City of Portland, Maine – Building or Use Permit Application 389 Congress Street, 04101, Tel: (207) 874-8703, FAX: 874-8716

Location of Construction: 5 Milk Street		Owner: Milk Street Assoc.		Phone: 772-6404		Permit No: 990772	
Owner Address: SAA		Lessee/Buyer's Name:		Phone:		Business Name:	
Contractor Name: Gaudet Const.		Address: 7 Brook Rd. Falmouth		Phone: 797-8866		Permit Issued: JUL 22 1999	
Past Use: office		Proposed Use: same		COST OF WORK: \$ 3,000.00		PERMIT FEE: \$ 42.00	
Proposed Project Description: Demo 20' of 2x4 Wall build 24' of new wall add 2 doors paint new wall				FIRE DEPT. <input type="checkbox"/> Approved <input type="checkbox"/> Denied		INSPECTION: Use Group: Type:	
				Signature: <i>[Signature]</i>		Signature: <i>[Signature]</i>	
Permit Taken By: K.		Date Applied For: July 13, 1999 K.		PEDESTRIAN ACTIVITIES DISTRICT (P.A.D.)		Zone: B-3 CBL: 029-A-003	
<ol style="list-style-type: none"> This permit application does not preclude the Applicant(s) from meeting applicable State and Federal rules. Building permits do not include plumbing, septic or electrical work. Building permits are void if work is not started within six (6) months of the date of issuance. F

5th Milk Street

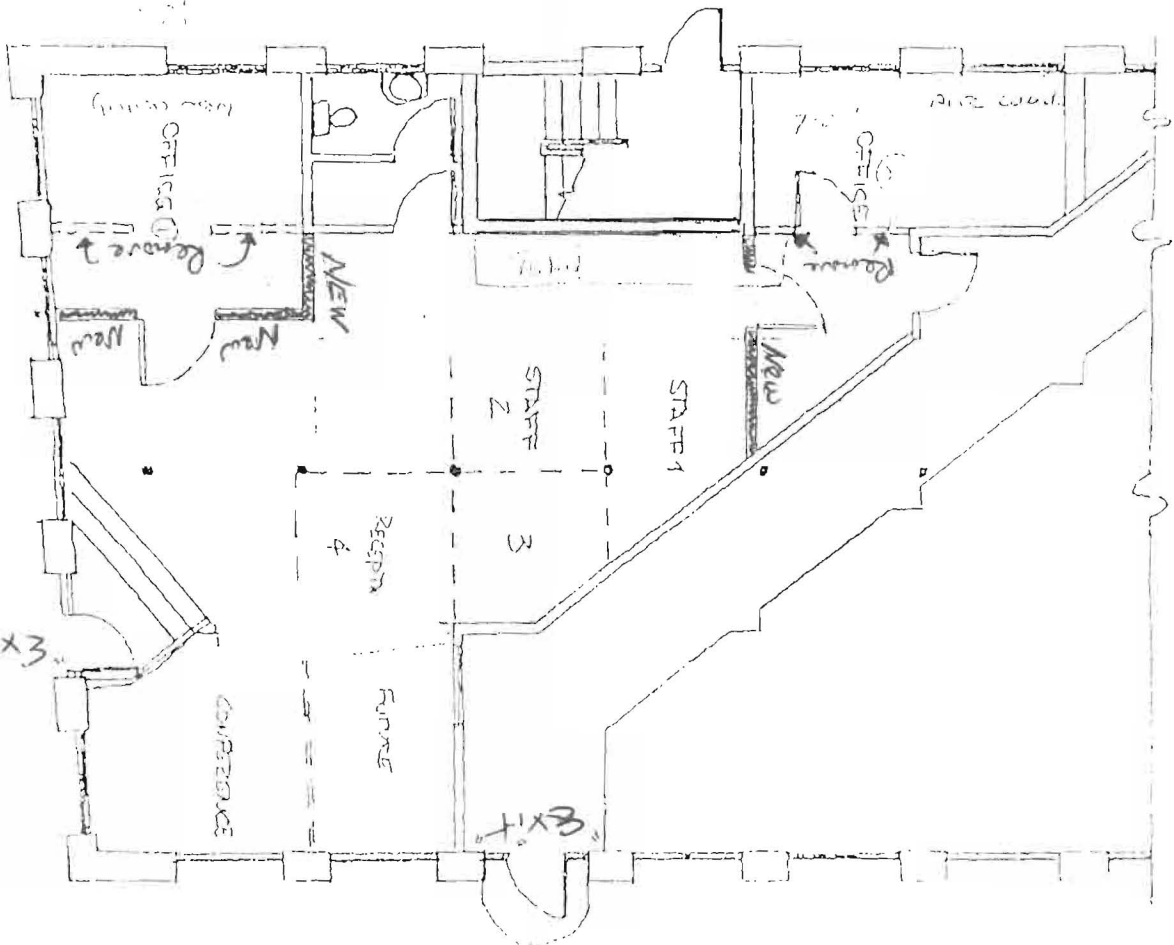
Demo 20' of wall
Build 24' of New Wall
with 2 Doors

No HVAC work

No Sprinkler work

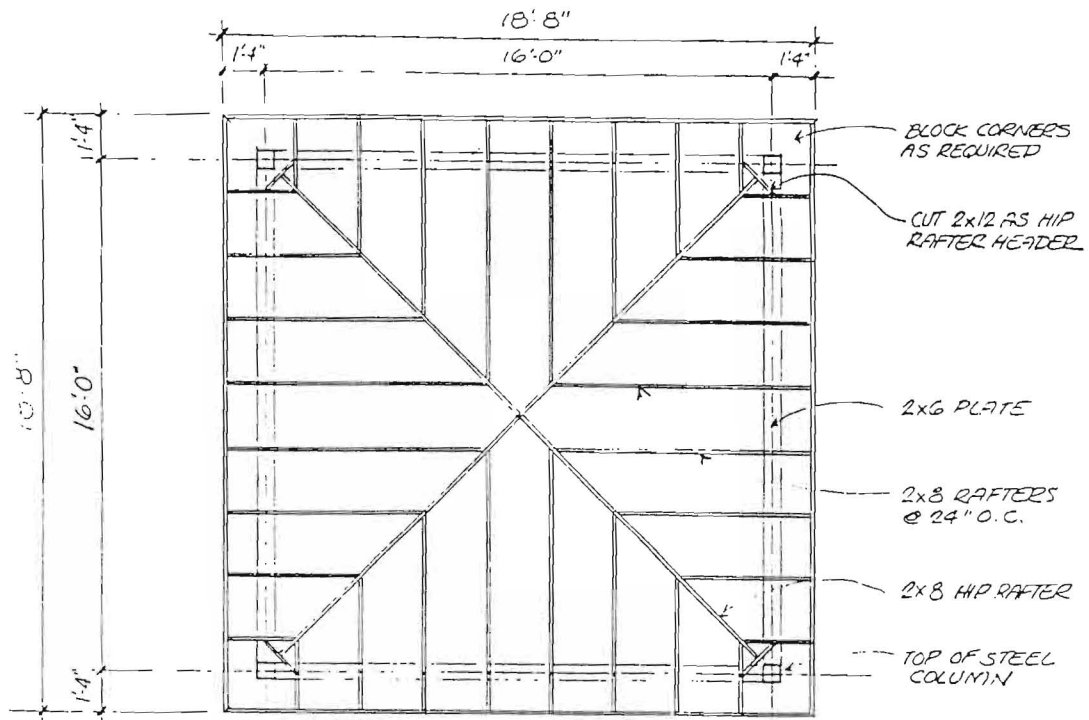
Approved with the following conditions: *1, *20, 22, *23 *27 *32 *34

33. Glass and glazing shall meet the requirements of Chapter 24 of the building code.
34. This permit is being issued with the understanding that NO bearing walls be removed under this permit.
